Access Compliance Report Public Rights-of-Way (Curb Ramps)

Main Street: WINFIELD_DR Cross Street: MASON_LN Location: NW

ADA ID: RPRK211025123617 Ramp Type: Type 4 - Parallel Initial Pass/Fail: Fail Overall Compliance: No Severity Score: 2

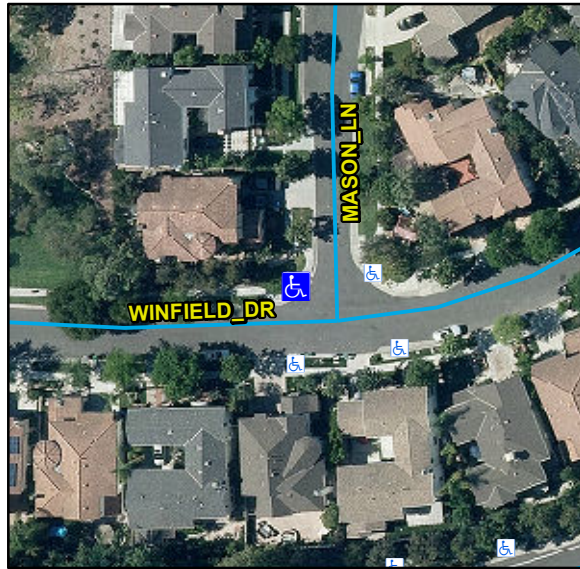
Compliance	Description	Data	Compliance	Description	Data
N/A	Ramp Length LT (in)	119	N/A	Ramp Length RT (in)	116
Yes	Ramp Width LT (in)	53	Yes	Ramp Width RT (in)	53
Yes	Ramp Run Slope LT (%)	2.5	Yes	Ramp Run Slope RT (%)	7.8
Yes	Ramp Cross Slope LT (%)	1.3	No	Ramp Cross Slope RT (%)	2.2
N/A	Landing Present	N/A	N/A	DWS Provided	N/A
N/A	Landing Length (in)	N/A	N/A	DWS Contrast	N/A
N/A	Landing Width (in)	N/A	N/A	DWS Length (in)	N/A
N/A	Landing Run Slope (%)	N/A	N/A	DWS Full Width	N/A
N/A	Landing Cross Slope (%)	N/A		DWS Offset Type	N/A
N/A	Landing Movement Obstructed?	N/A	N/A	DWS Offset Left (in)	N/A
	Landing Movement Type	N/A	N/A	DWS Offset Right (in)	N/A
N/A	Landing Shared	N/A			
N/A	Clear Space	Yes			
N/A	Clear Space To Crosswalk (in)	N/A			
N/A	Marked Crosswalk 1	No	N/A	Marked Crosswalk 2	No
	Crossing 1 Direction	S		Crossing 2 Direction	E
	Marked Crosswalk 1 Width (in)	N/A		Marked Crosswalk 2 Width (in)	N/A

Remove & Replace Curb Ramp With Two New Directional Ramps or Equivalent.
